Attention: Application Examiner / Review Engineer**Reference:** Class II permissive change for FCC ID: Q9DMST200

This is to request for Class II permissive change for FCC ID: Q9DMST200 originally granted on 5/30/2012.

The commonality and difference between MST2H13N0 (POE version) and MST2H13N1 (AC version):

MST2H13N0 (POE version)	MST2H13N1 (AC version)	Note
		Merged most cards into one main board. MST2H13N 1 is powered by AC Power module.
		Upper photo is heater mounted; While lower photo is heater removed.
		Same radio card.
		Same antenna

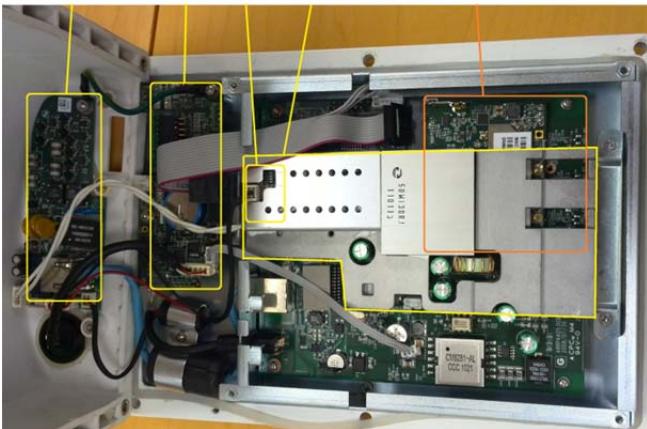
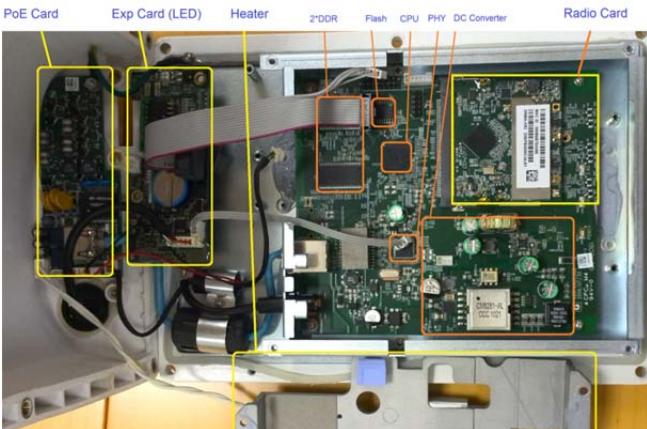
<p>Merged into main board</p>	<p>PoE card consisted of RJ45 Connector and PD controller etc.</p>
	<p>Merged into main board</p>	<p>Exp card consisted of I2C expander (as LED driver), Watch dog timer, RTC etc.</p>
	<p>Merged into main board</p>	<p>Temperature sensor card (with heater control)</p>
		<p>Same external enclosure form factor, except for adding an AC connector.</p>
